## STAFF REPORT

### DESIGN COMMISSION STUDY SESSION

| <b>Project No:</b>       | DSR20-005  |
| <b>Description:</b>      | Mercer Park office building renovation: <ol style="list-style-type: none"> <li>1. Renovating the east building facade;</li> <li>2. Modifying the front entry and plaza; and,</li> <li>3. Renovating the third floor roof to create an outdoor deck area.</li> </ol>      |

# EXTERIOR TREE REMOVAL RELOCATION PLAN

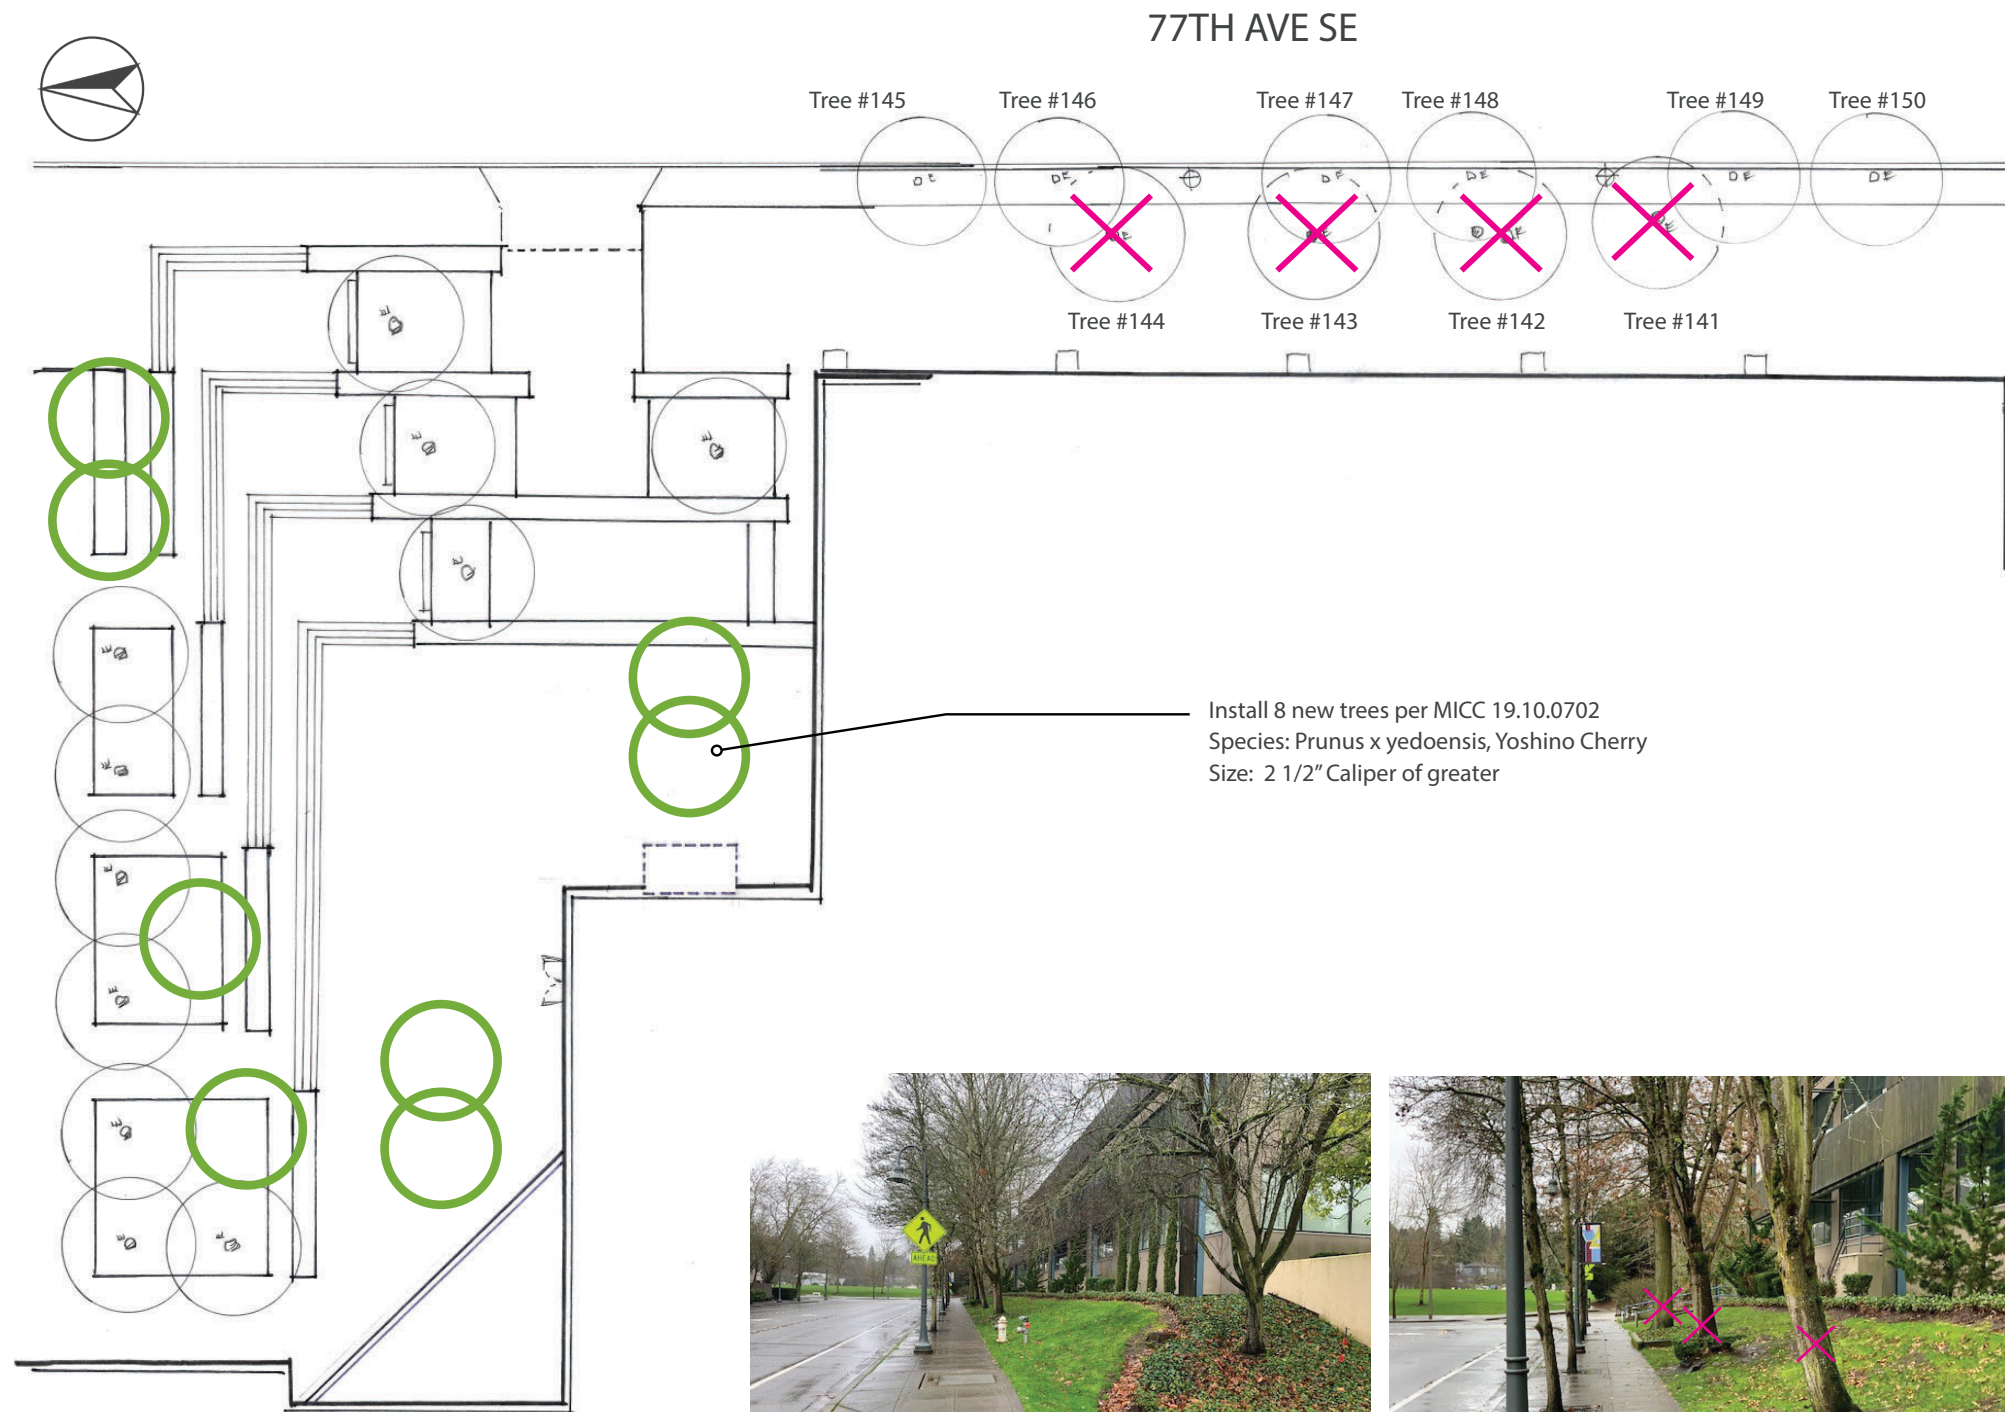
Landscaping standards are listed in MICC 19.11.070. The applicant is not proposing to change the amount of landscaped area; the project scope is a revision to existing landscaped areas. MICC 19.11.070(B)(2)(b) requires that existing prominent trees be retained to the extent feasible. The applicant has proposed to remove four existing trees along the east building façade to allow for excavation to both install drainage improvements and modify the building façade to allow daylight into the lowest level of the building (Exhibit 2: Mercer Park Conceptual Plans, pages 7-8). The applicant does intend to retain the existing street trees. The conceptual landscaping plan (Exhibit 2: Mercer Park Conceptual Plans, pages 3-5 and 7-8) appears to be consistent with the provisions of 19.11.070.

# EXTERIOR ROOF TERRACE 4TH FLOOR

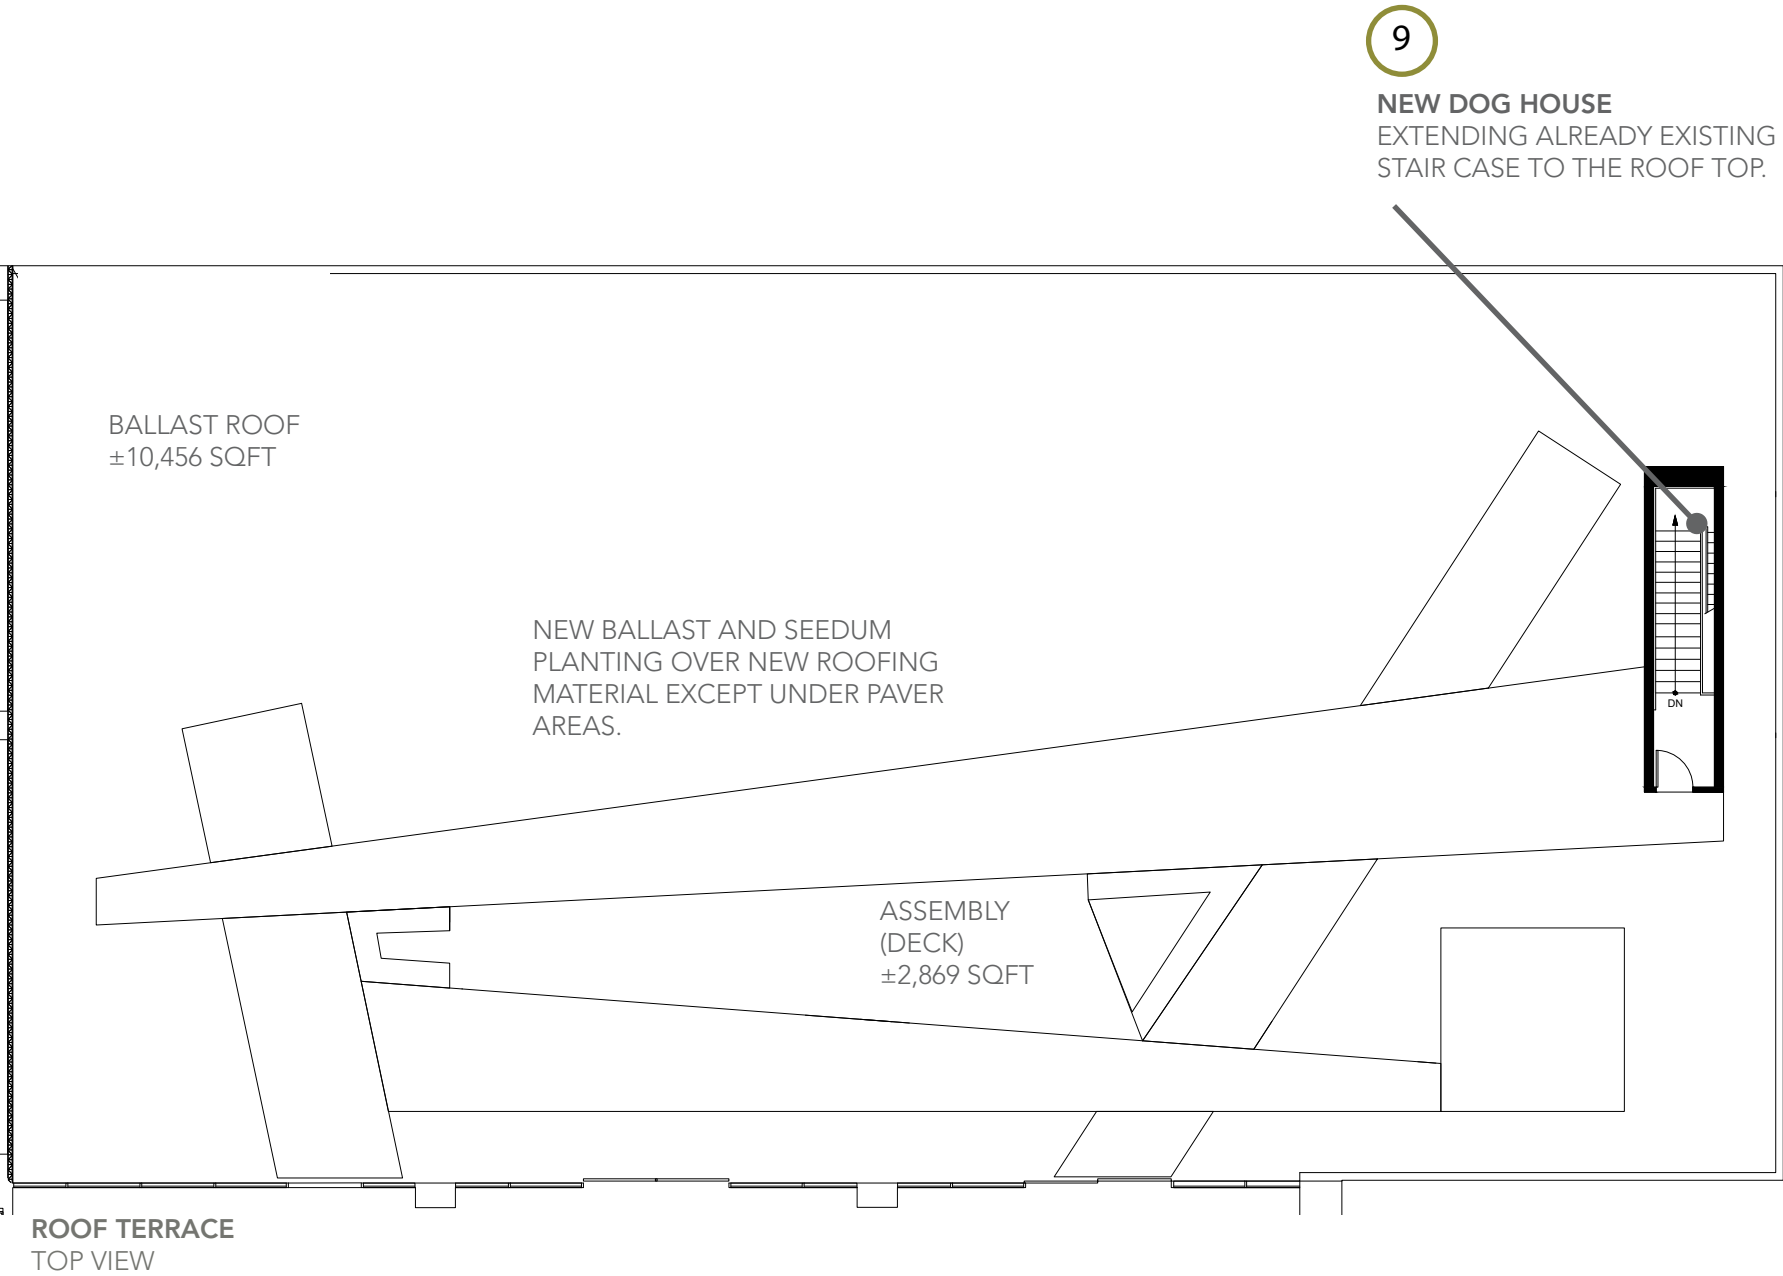
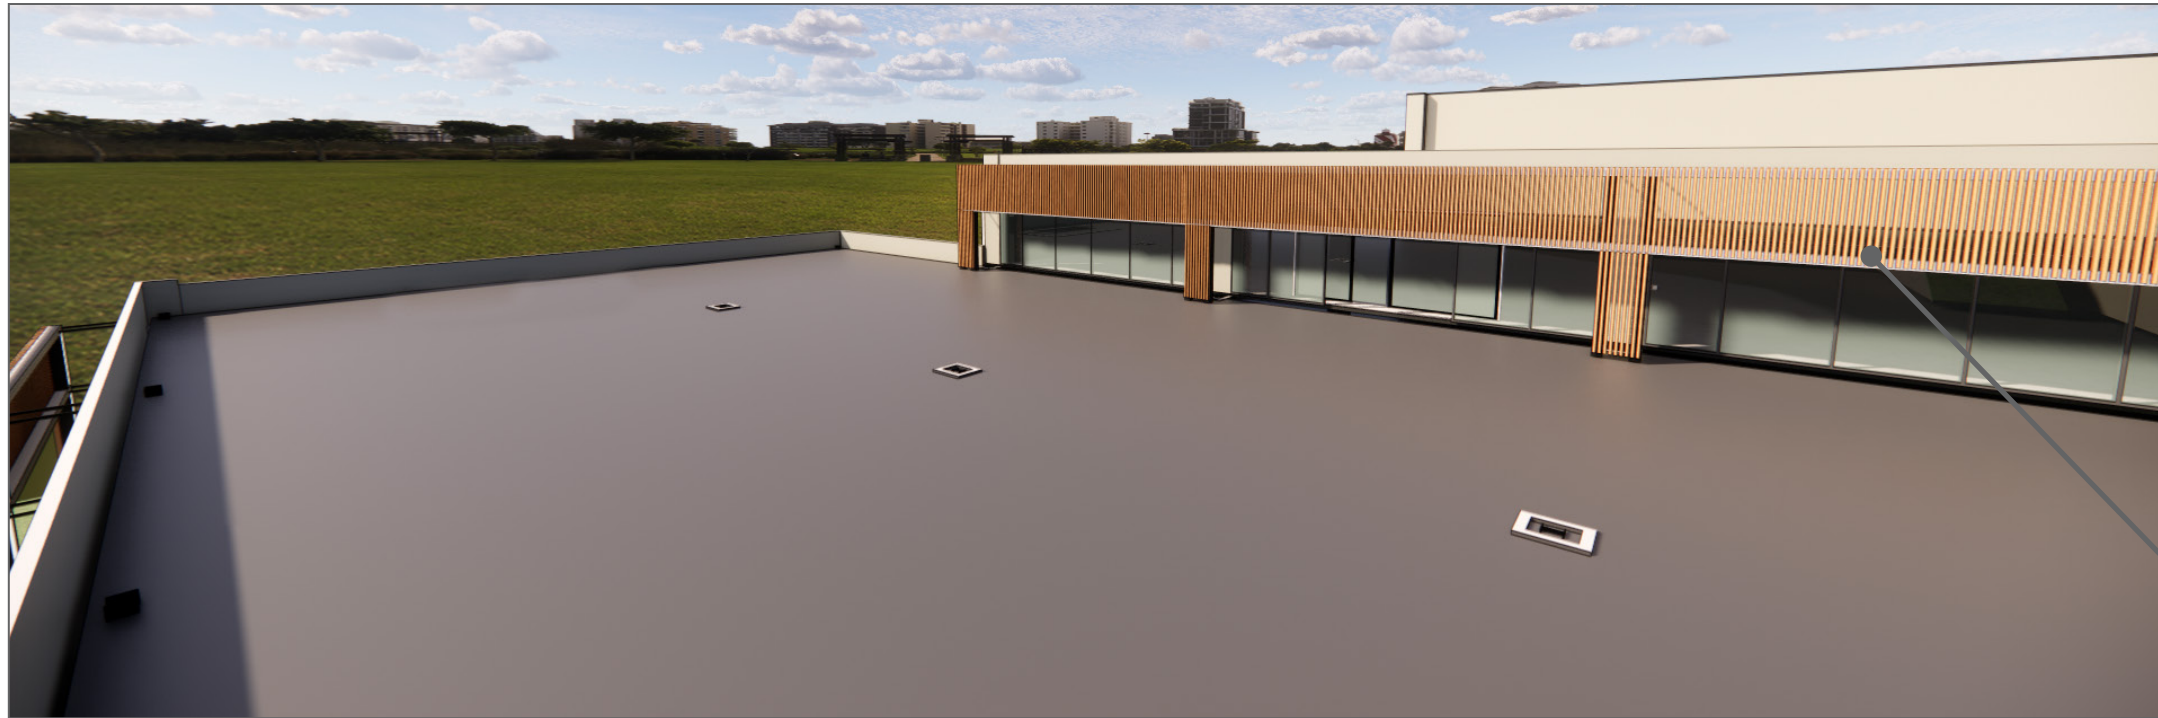
The proposed “dog house” providing stair access to the rooftop deck area is a rooftop appurtenance located more than 10 feet to the west of the existing eastern parapet wall (Exhibit 2: Mercer Park Conceptual Plans, pages 12 and 13). Pursuant to MICC 19.11.030(A)(5), rooftop appurtenances are generally discouraged except where there is a functional need for the appurtenance. The proposed stair access is necessary to allow for the safe use of the rooftop deck area, which is a functional need. The proposed rooftop appurtenance appears to be screened by the existing parapet walls on the east and south sides of the building. The proposed stairway dog house rooftop appurtenance generally appears to be consistent with MICC 19.11.030, although additional detail during design review will be required to

ensure the rooftop appurtenance does not exceed the 10 foot height limit and is fully screened along the southern façade exposure.
